## **Appendix A.3 Agency Consultation**

### **Part 2**

**From:** [Steiner, Michael \(MTO\)](#)  
**To:** [Larkin, Ann](#)  
**Cc:** [Green-Battiston, Melissa](#); [Bartlett, Isaac](#); [Hohner, Paula](#); [Smith, Neal](#)  
**Subject:** RE: Norval West Bypass Schedule C MCEA - Draft ESR for Review  
**Date:** Friday, August 29, 2025 11:31:15 AM  
**Attachments:** [image001.png](#)  
[image002.png](#)  
[image003.png](#)

**From:** Larkin, Ann <[Ann.Larkin@halton.ca](mailto:Ann.Larkin@halton.ca)>  
**Sent:** Tuesday, July 29, 2025 3:56 PM  
**To:** Steiner, Michael (MTO) <[Michael.Steiner@ontario.ca](mailto:Michael.Steiner@ontario.ca)>  
**Cc:** Green-Battiston, Melissa <[Melissa.Green-Battiston@halton.ca](mailto:Melissa.Green-Battiston@halton.ca)>; Bartlett, Isaac <[isaac.bartlett@stantec.com](mailto:isaac.bartlett@stantec.com)>; Hohner, Paula <[paula.hohner@stantec.com](mailto:paula.hohner@stantec.com)>; Smith, Neal <[Neal.Smith@halton.ca](mailto:Neal.Smith@halton.ca)>  
**Subject:** Norval West Bypass Schedule C MCEA - Draft ESR for Review

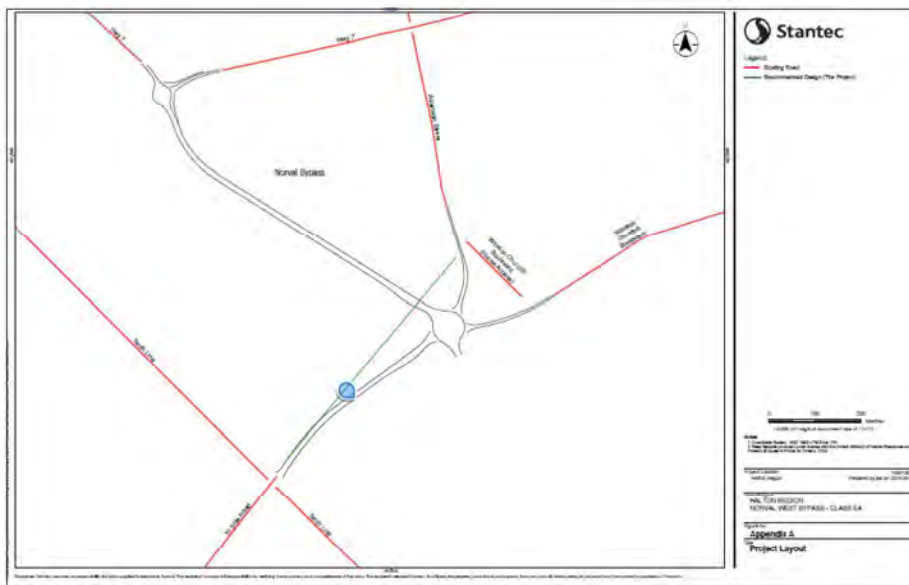
2. What is the proposed pavement type to be used in the project and how does it compare to the pavement type that was modelled?
3. The figure in Appendix A – Project Layout appears to include the existing roads in red. It is not clear whether this figure was taken directly from the noise model or created separately. If it is from the noise model, I am concerned that it may underrepresent noise in close proximity to the roundabouts. Perhaps the easiest way to clear this up is to request some figures or screenshots of the noise model in TNM.

4. It also appears that the 10 Side Road is missing, east of Tenth Line. Please confirm that this road was included in the traffic noise modelling, as appropriate. (I have drawn a green line where I think it might go)

1. Roundabouts, as shown in Figure 2-1, were considered in the assessment and were modeled as part of the road segment without a speed reduction. This conservative approach ensures that the future build scenario captures the highest potential sound levels.
2. For the purposes of the noise assessment, the "Average type" asphalt pavement was used as part of the modeling.
3. The existing 10 Side Road was included in the No-Build project scenario, while the realigned 10 Side Road was included in the Future-Build project scenario. Existing roads that remain unchanged are shown in red in the figures in Appendix A of the Noise Report. The legend for the figure will be updated.
4. Yes, 10 Side Road was included in the model, see

|                                                                                                                                                                                                                                                                                                                                                                                                                                                                                                                                                                                                                                                                                                                                                                                                                                                                          | above response<br>for comment #3.                                                                                                                                                                                                                                                                                                                                                                                                                                                                                                                                                                                                       |

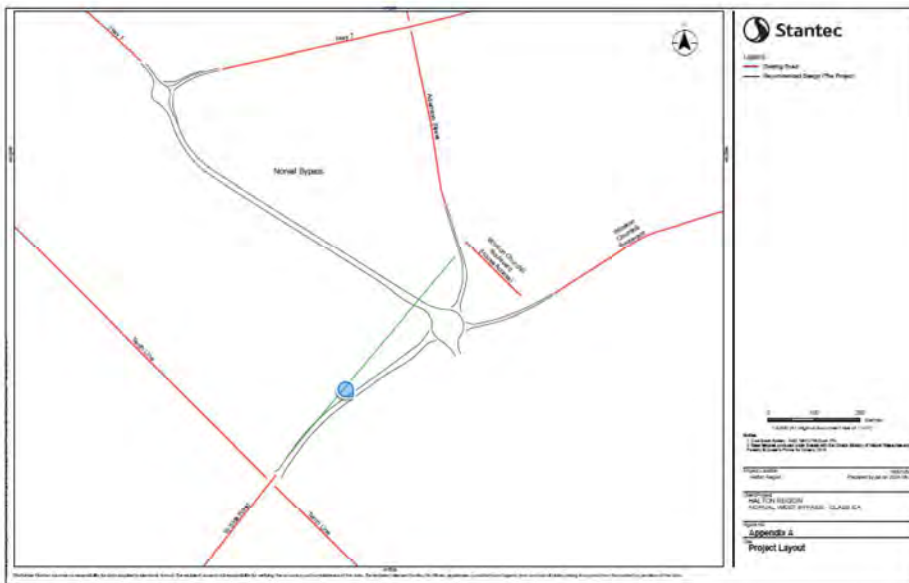
6. What is the proposed pavement type to be used in the project and how does it compare to the pavement type that was modelled?
7. The figure in Appendix A – Project Layout appears to include the existing roads in red. It is not clear whether this figure was taken directly from the noise model or created separately. If it is from the noise model, I am concerned that it may underrepresent noise in close proximity to the roundabouts. Perhaps the easiest way to clear this up is to request some figures or screenshots of the noise model in TNM.

8. It also appears that the 10 Side Road is missing, east of Tenth Line. Please confirm that this road was included in the traffic noise modelling, as appropriate. (I have drawn a green line where I think it might go)
